BEING 70.019 ACRES OF LAND OUT OF THE W.W. ALLEN SURVEY NO. 353, ABS. 34, C.B. 4866, BEXAR COUNTY, TEXAS. MASTER DEVELOPMENT PLAN/P.U.D. for BELTERRA SUBDIVISION

Re: Belterra Subdivision

MDP # 819

The City Staff Development Review Committee has reviewed Belterra Subdivision Master Development Plan M.D.P. # 819. Please find enclosed a signed copy for your files. Your plan was accepted, however please note the following:

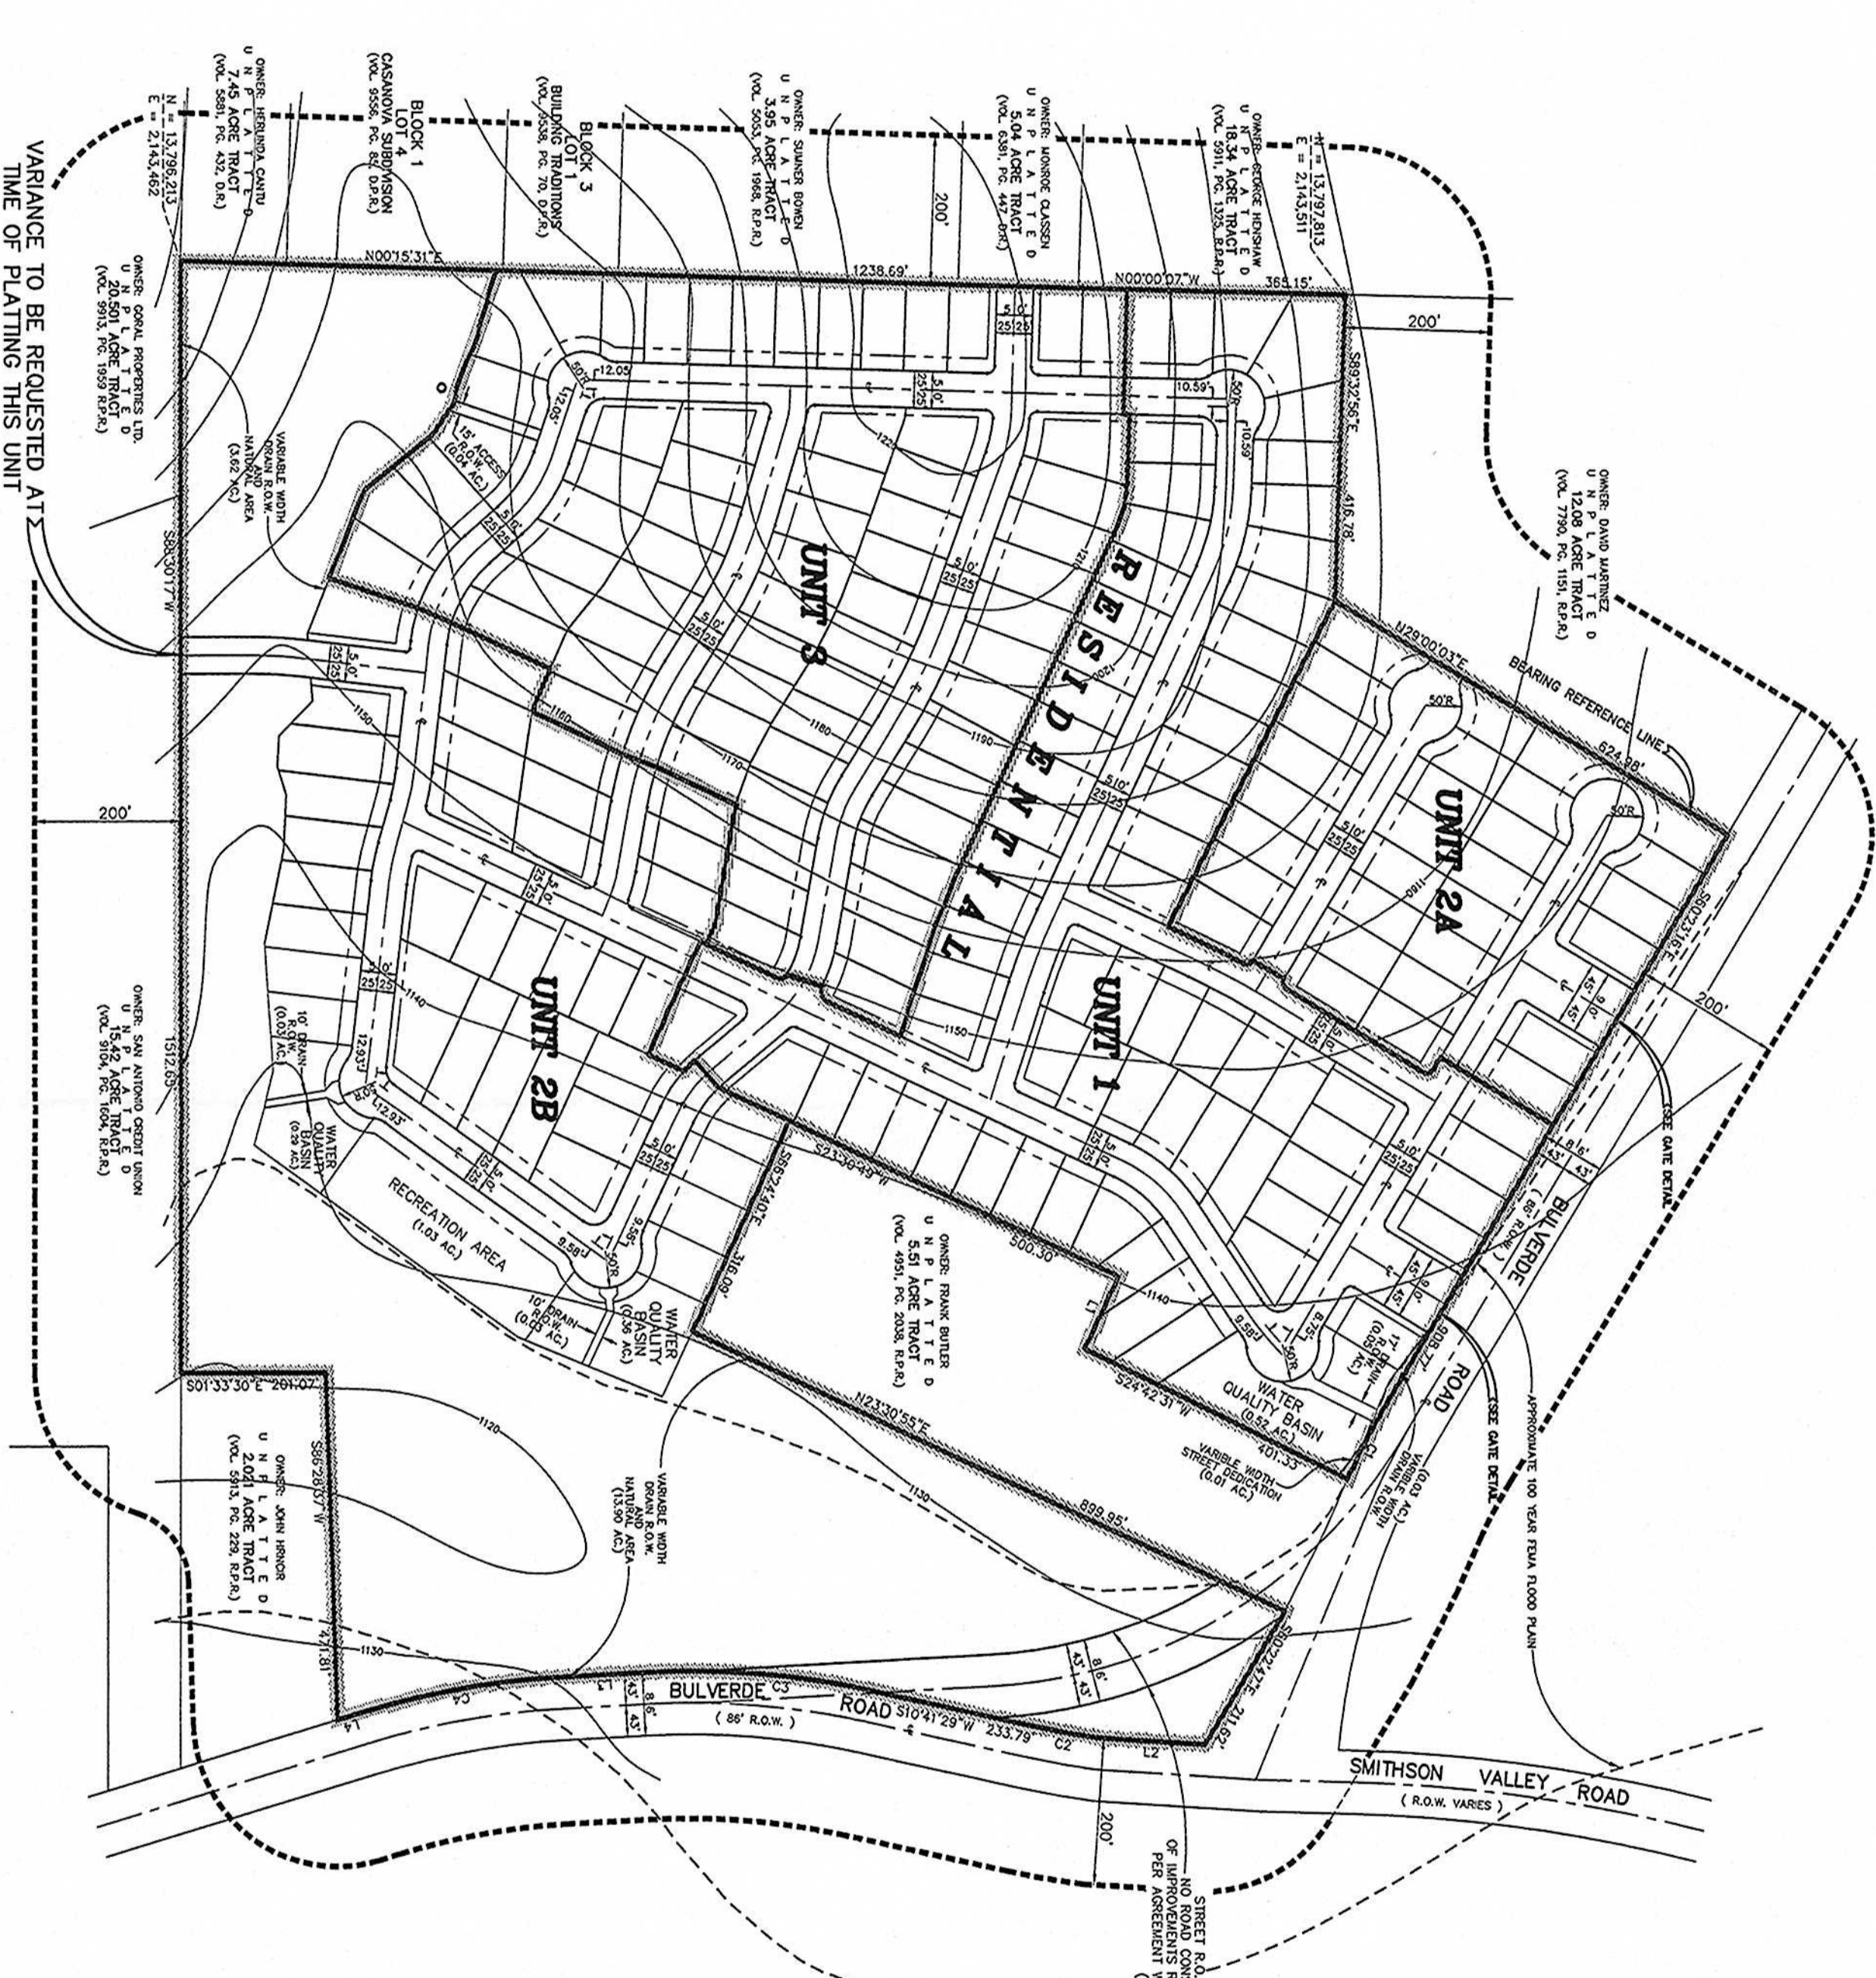
- a. Provide typical street section that stipulates pavement width.
    - b. On the Bulverde Road side of the gate detail, move the handicap ramps to the apex.

2. The following issue should be addressed during the respective platting process: Evaluate potential excessive grades on several streets in Units 1 and 3.
